REQUEST

SUMMARY OF PETITION

The petition proposes to allow up to 73 attached dwelling units at a density of 7.3 units per acre, on vacant land adjacent to Catawba Village Shopping Center at the intersection of Mt. Holly-Huntersville Road and Mount Holly Road.

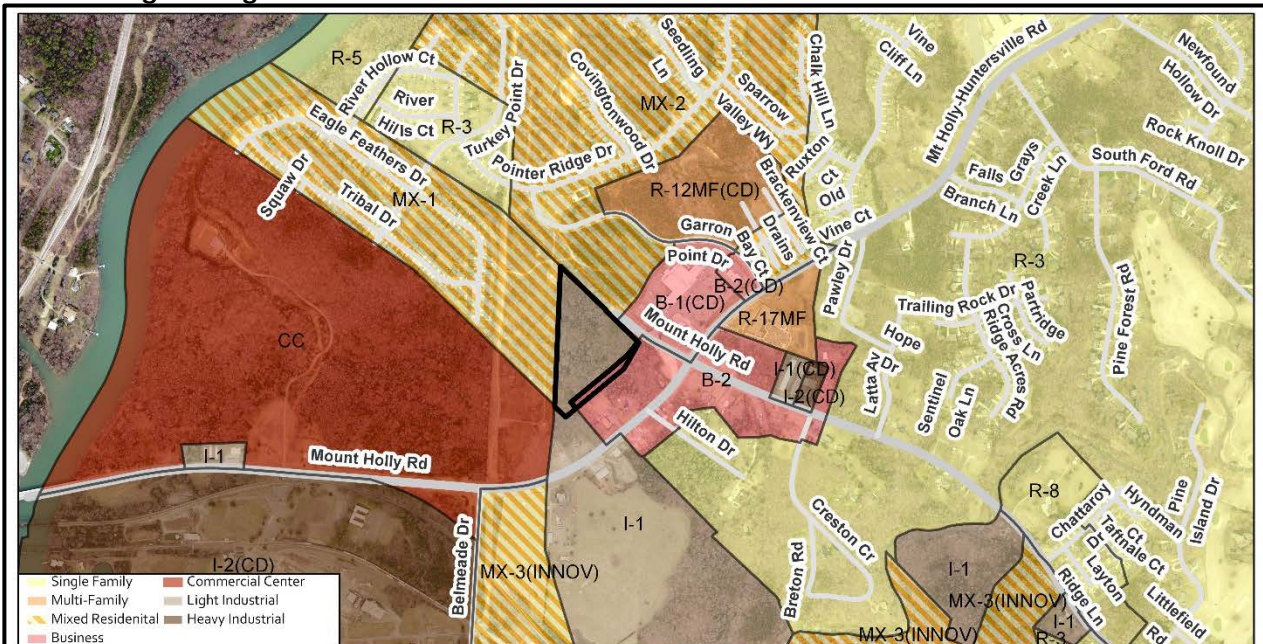
4. ~~Modify Architectural Standards Note 6 to state that stoops will be a minimum six feet in depth.~~ Addressed
5. ~~Modify Streetscape, Landscaping and Open Space Note 1 to identify minimum amenities to be provided in common open space areas.~~ Addressed
6. ~~Remove elevations on sheet RZ-2 if not representative of actual architectural elements.~~ Addressed

7. ~~Petitioner needs to clarify if the expectation is that CDOT abandon the 30-foot right-of-way along Mt. Holly Road.~~ Addressed
8. ~~Modify General Provisions Note 1 as there is no Sheet CP-1.~~ Addressed
9. ~~Modify Permitted Uses Note to indicate only up to 70 attached dwelling units.~~ Addressed
10. ~~Numerical order on Sheet RZ-2 is incorrect.~~ Addressed
